**Subject: Cell 4 – Green-Croissant Pit  
Reclamation Slope Evaluation Version 2**

- Corrects typos, and mis-interpretation of the Rule to address comments by DRMS (Hays, 2022)
- Summarizes our evaluation of the existing reclamation slopes at the above referenced mine cell
- Compares our analysis to that provided by Ms. McGill (McGill, 2021)
- Evaluates the Division of Reclamation, Mining and Safety's (DRMS's) correspondence intimating a regrade requirement of Zones 9, 20, 25, 26 and part of 27 (Hays, 2021)

ZONE 20 COMPARISON

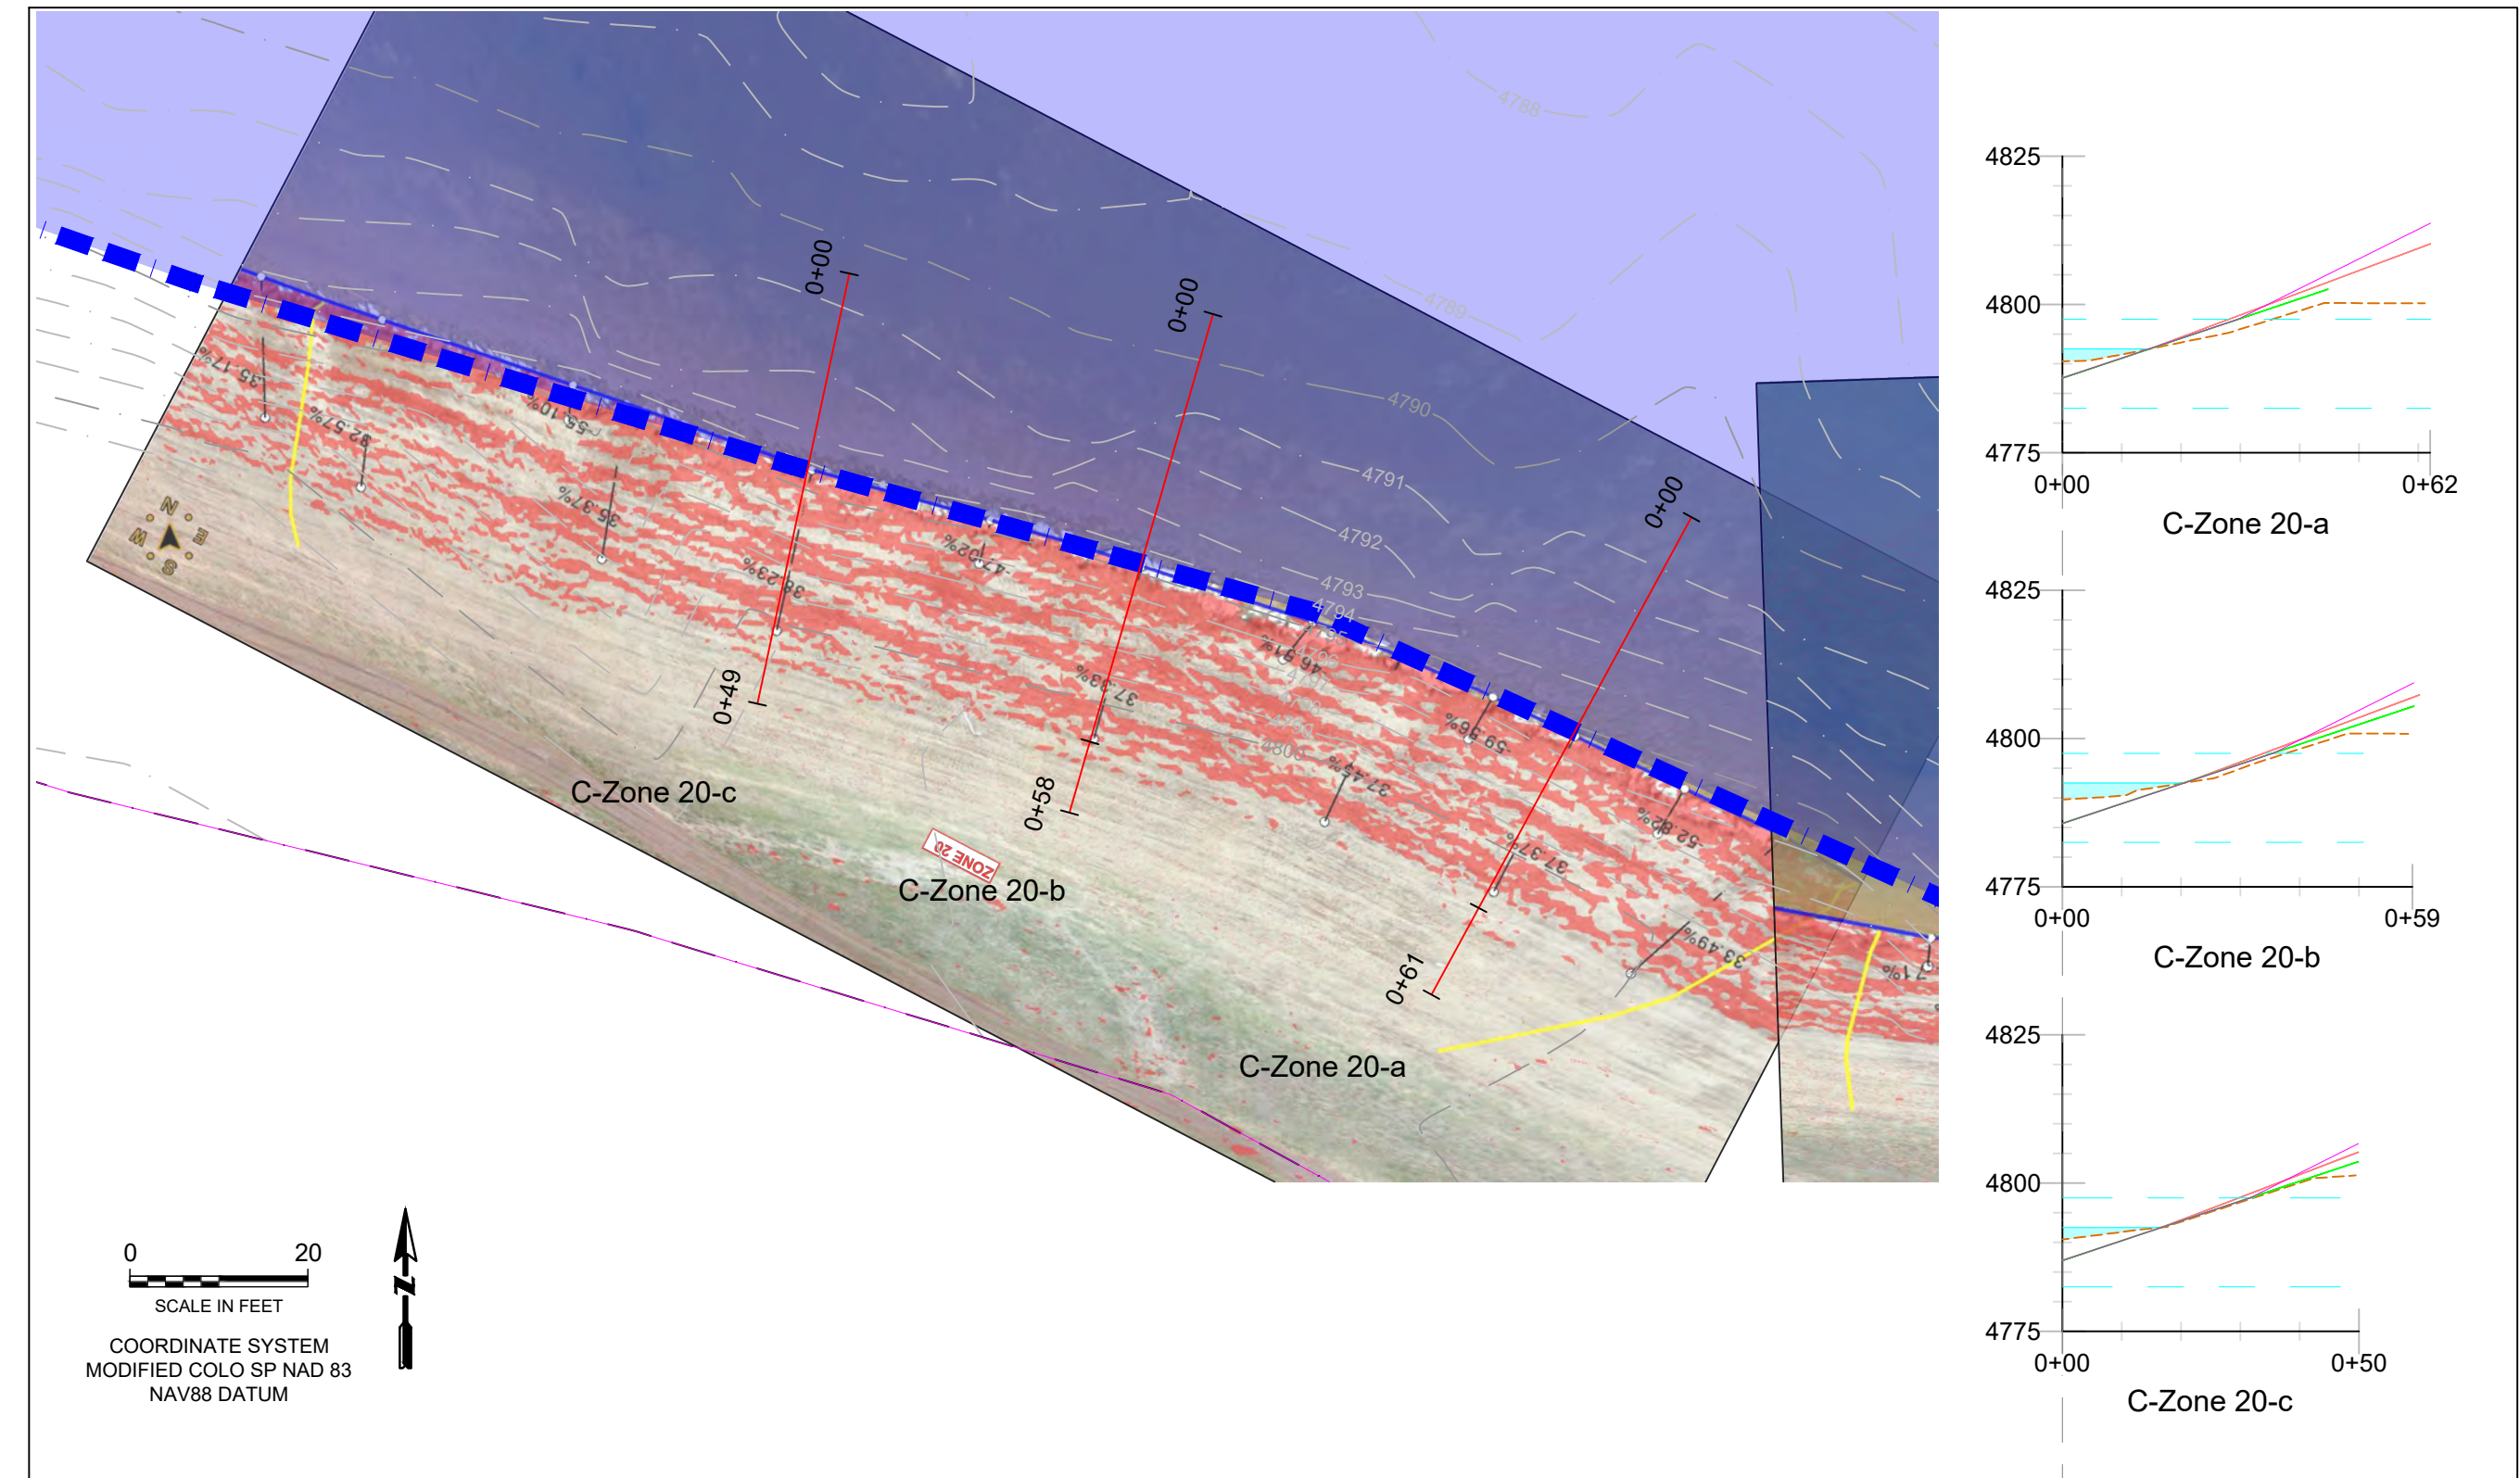
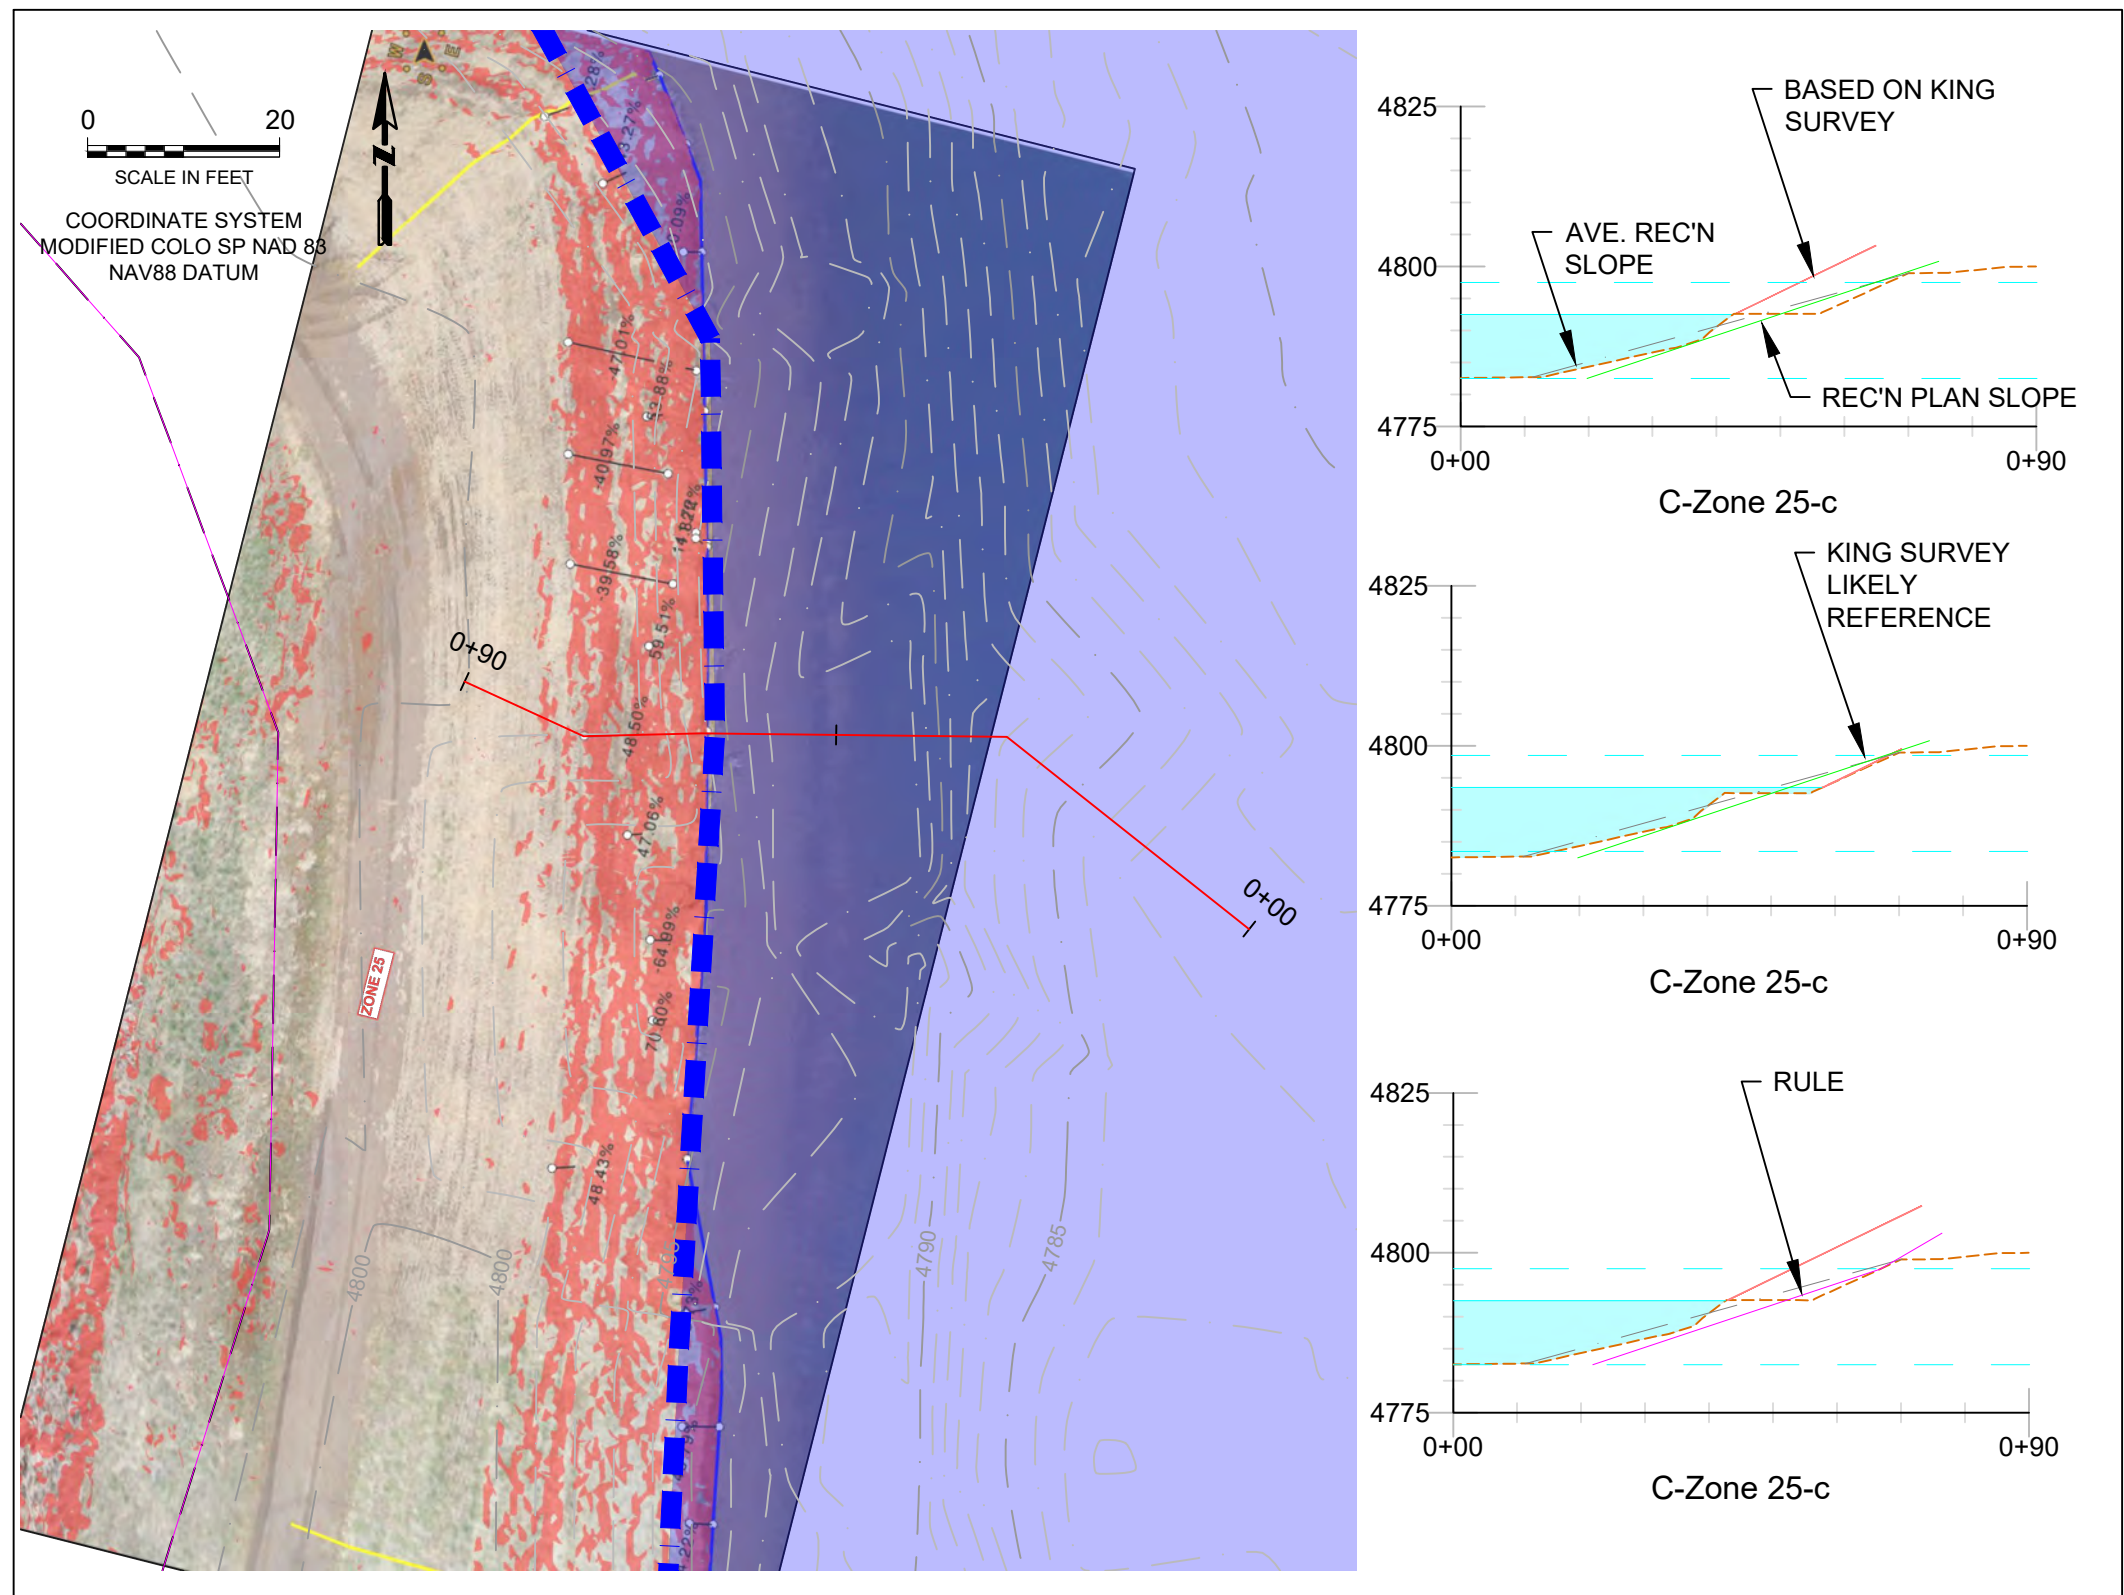
We chose Zones 12, 19 and 20 for comparison purposes. The King Survey shows, generally, that slopes in Zone 12 are gentle, Zone 19 are right at Rule slopes, and Zone 20 is steeper. This allowed a range of slope estimation comparison. We overlaid the images provided in the King Survey that showed their slope estimates into AutoCad. We then placed sections, perpendicular to the topographic contours near the King Survey evaluation locations and repeated the process described in the previous section. We placed the cross sections such that King's point closest to the water's edge runs through the cross section. Then on each cross section, we plotted King's reported slope by percentage. We also repeated the comparison in Zone 25 at the maximum slope indicated by King.

Most of the reported slopes in the King Survey were too short and biased by local irregularities (e.g., plow lines from drill seeding and cross ripping placed for soil retention and seed germination) for us to use in comparison. To calculate slopes, the approach should utilize the Rule's slopes 5 feet above and 10 feet below the water surface. Thus, we used the few King Survey slope calculations that were of appropriate length in our comparison. Sheet 2 summarizes the comparison between the King Survey and the PLS Corporation survey and our interpretation. Zones 12 and 19 show that the beginning and ending points the King Survey used for slope calculations generally agree with the PLS Corporation survey. In Zone 20, the King Survey shows slightly steeper slopes than those based on the PLS Corporation survey. The information provided on the King Survey (McGill, 2021) is in PDF format with no vector information, and some of the images appeared to be at a skewed angle. This could account for some of the discrepancy between the surveys in that the section location we attempted to mimic could be off slightly.

ZONE 20

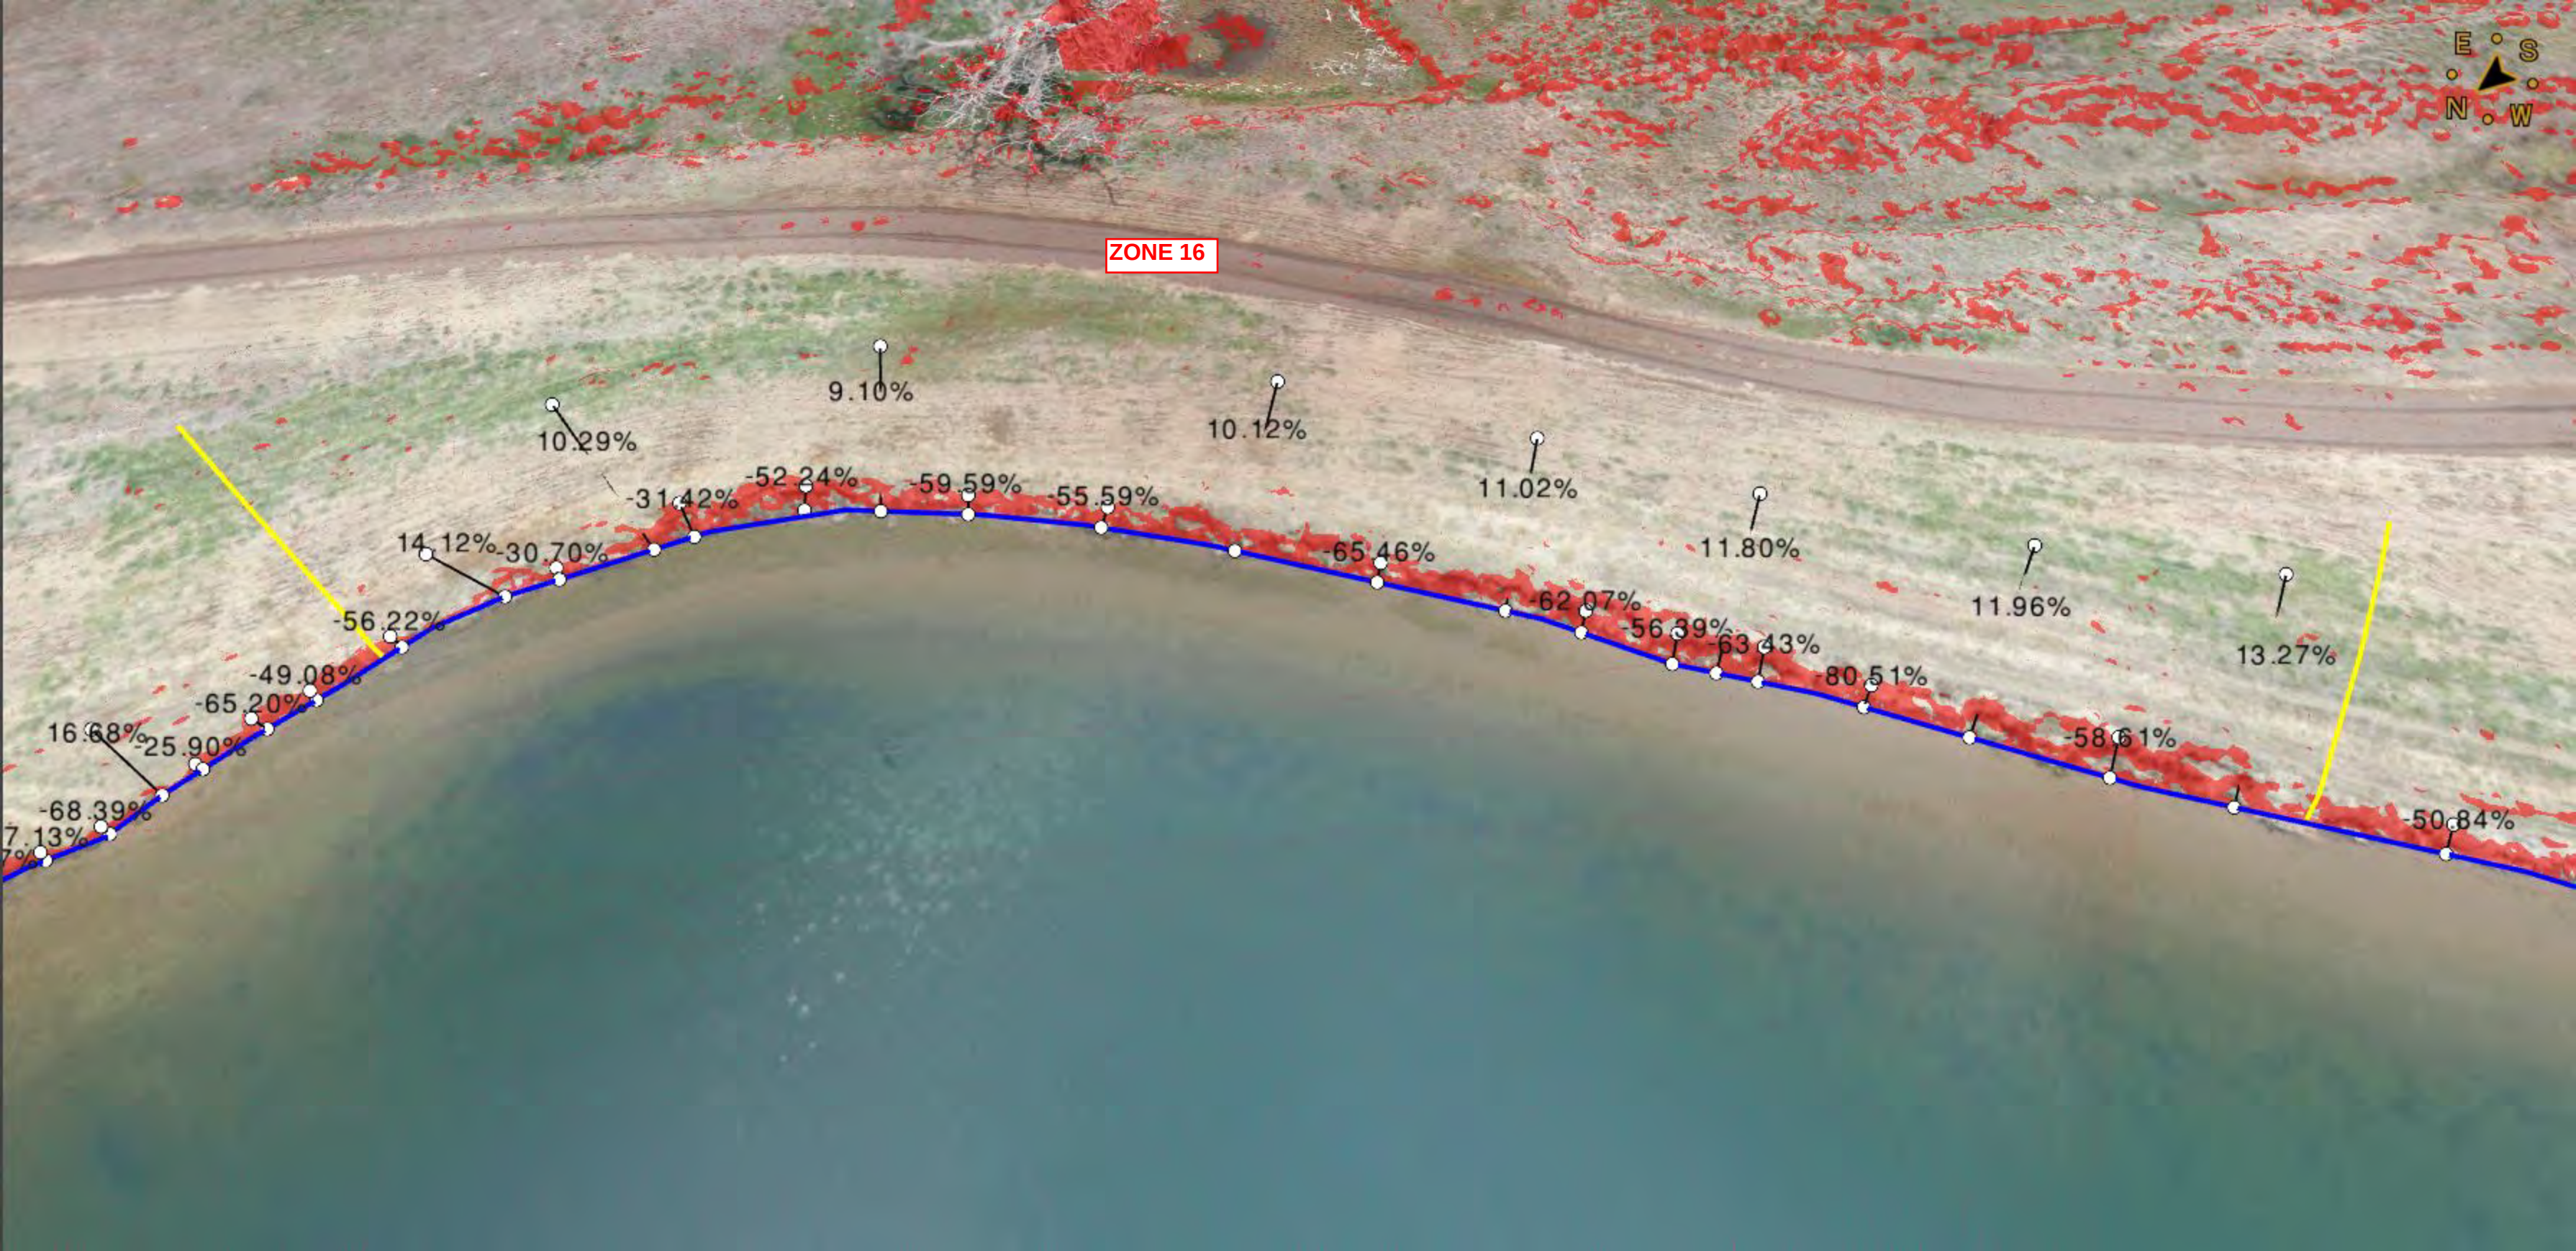
Zones 19,20,21,22,23 is where the violation on the June 24th report was asked to be corrected as you can see it has not been corrected to the standard of 3:1 set by state.

- Zone 9: Both sections (Zone 9-a and Zone 9-b) show the overall reclamation slopes at or shallower than 3H:1V. In terms of the Rule, Zone 9-a is shallower and 9-b is within 2% of 3H:1V
- Zone 20: Both sections (Zone 20-a and 20-b) show slope compliance for LRM's reclamation slope and the Rule
- Zone 25: Section Zone 25-a is shallower than LRM's reclamation plan and Rule requirement. Section Zone 25-b is within 15% and 5% for the Rule requirement below the water surface and LRM's reclamation plan, respectively
- Zone 26: Zone 26-a mimics the shape of Zone 25-b and is within 21% and 4% for the Rule requirement below the water surface and LRM's reclamation plan, respectively. Zone 26-b meets the requirements except for the Rule below the water surface elevation where it is within 12%
- Part of Zone 27: Meets all criteria
